RE: **Recall Campaign Launch Notification**
High Voltage Wiring Harness
MY20 253 (GLC-Class)

Campaign No. 2020110008, December 2020

SUBJECT: **Model GLC-Class vehicles (253 platform)**
Model Year 2020
High Voltage Wiring Harness

Figure 1 (example illustration on model 213 with OM654)

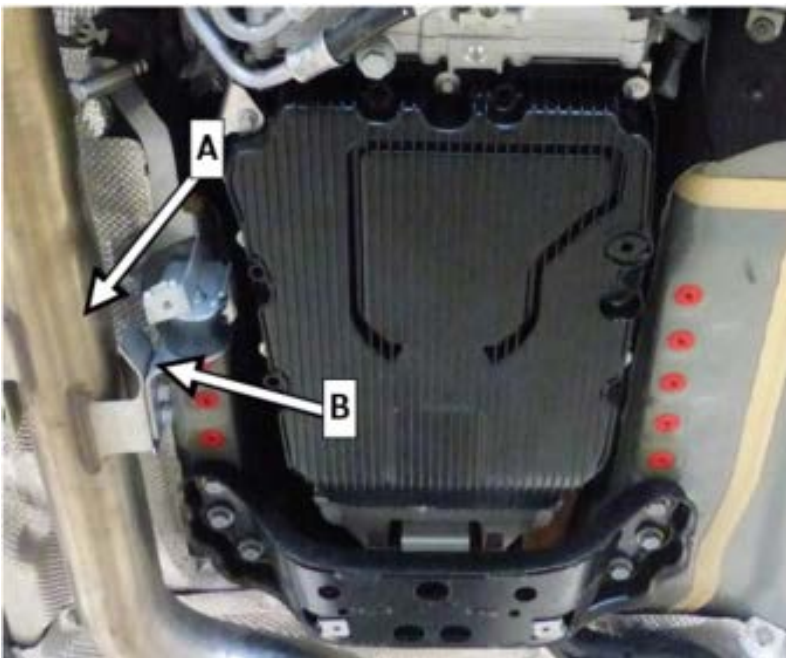
3. Remove exhaust system (A, Figure 1) from transmission bracket (B, Figure 1).

Figure 2 (example illustration on model 213 with OM654)

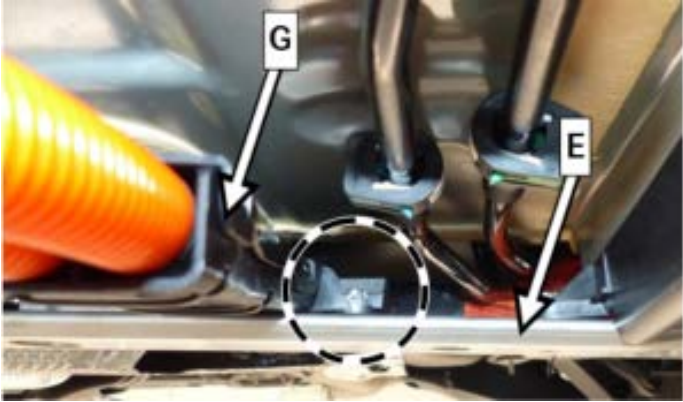
5. Remove cable duct (**G, Figure 2**) from cross strut (**E, Figure 2**).

Figure 3 (example illustration on model 213 with OM654)

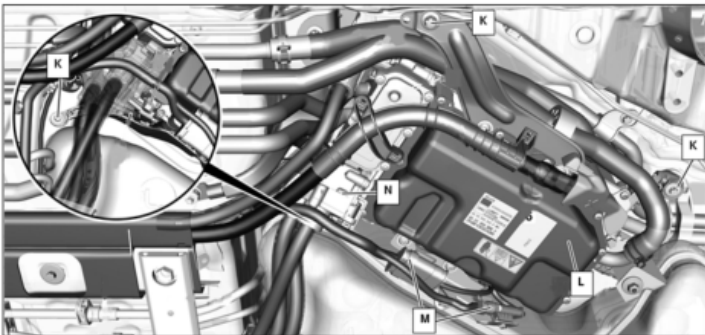
8. Expose power electronics (**L, Figure 3**), release and lower.

9. Expose high-voltage plug (**N, Figure 3**) of high-voltage wiring harness on power electronics (**L, Figure 3**), detach and remove.

Figure 4 (example illustration on model 213 with OM654)

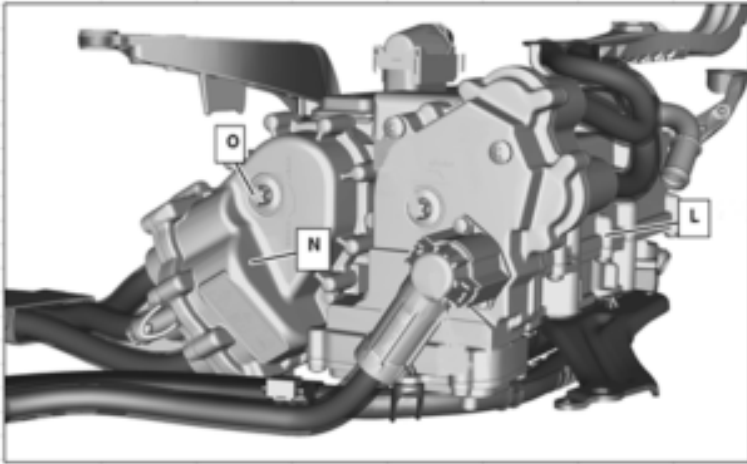
10. Remove screw (**O, Figure 4**) and remove high-voltage plug (**N, Figure 4**).

i The screw (**O, Figure 4**) remains in the high-voltage plug (**N, Figure 4**).

Figure 5 (example illustration on model 213 with OM654)

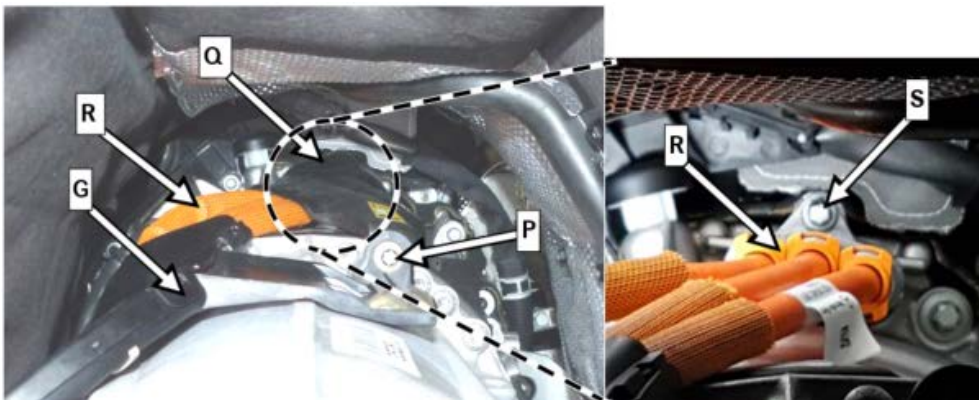
12. Remove cable duct (**G, Figure 5**) at side from transmission.

13. Remove screw (**P, Figure 5**) and remove upper cover (**Q, Figure 5**) above the high-voltage plug connector (**T, Figure 5**).

14. Remove screw (**S, Figure 5**) and remove high-voltage wiring harness (**R, Figure 5**) with cable duct (**G, Figure 5**).

Hm Screw for cover on transmission **9 Nm**

Hm Screw for high-voltage wiring harness plug on transmission **10 Nm**
